Addendum #4
Project #2767A
Brown County Port Development Project
Port & Resource Recovery
October 31, 2025
Request for Bid

Addendum #4

- To start answering questions received for project

B SECTION
100 TONNE T-BOLLARD SCALE: 1/8"=1'-0"

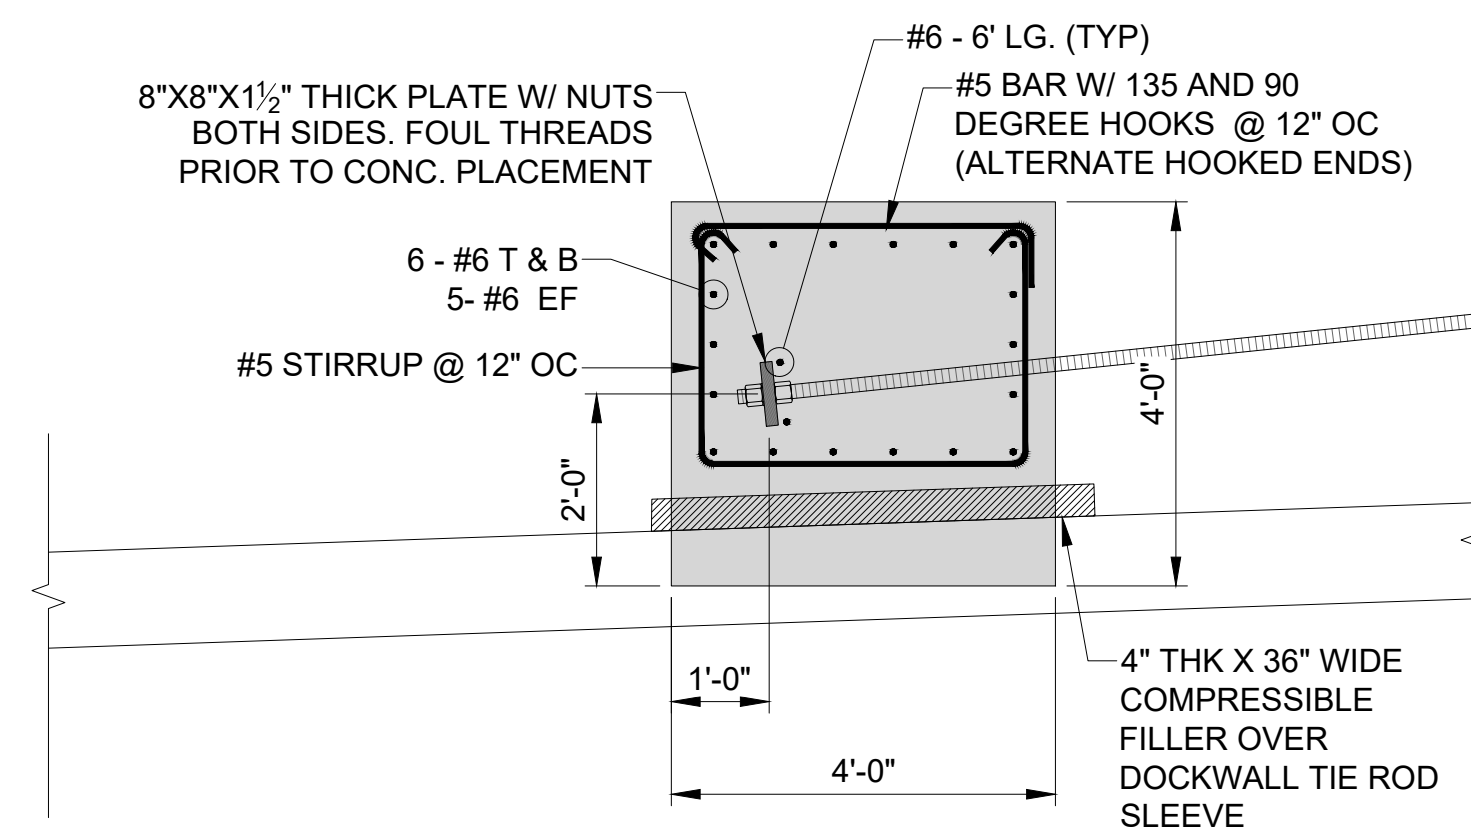
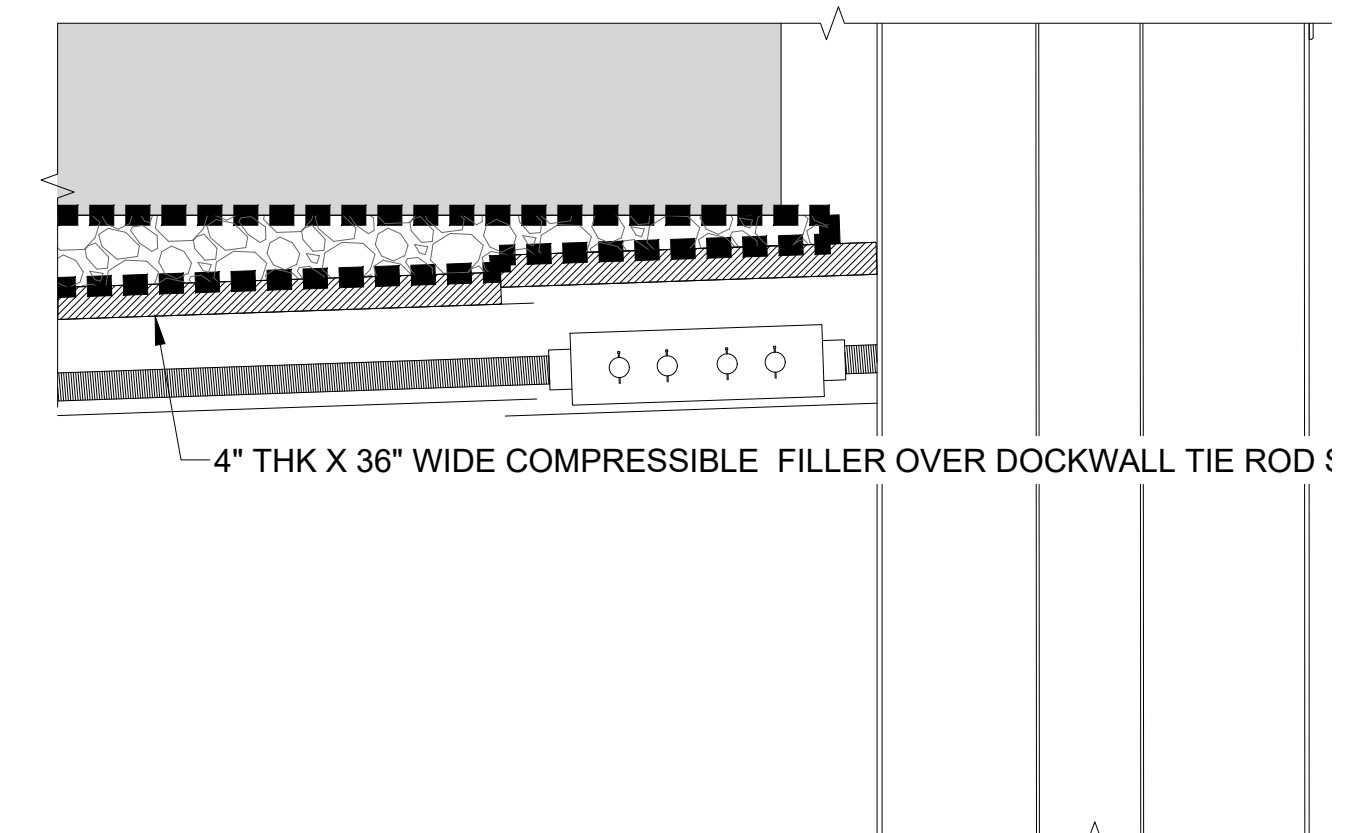
5. **QUESTION:** Attachment B item 3.3 Mooring Bollards The qty shows 17 ea. Drawing SM101 shows 16 ea. Please confirm what quantity is correct.

RESPONSE: There should be one additional bollard on the far north end of the dock wall for securing the end of the ship, resulting in 17 bollards. Sheet SM-101 has been revised to include this additional bollard.
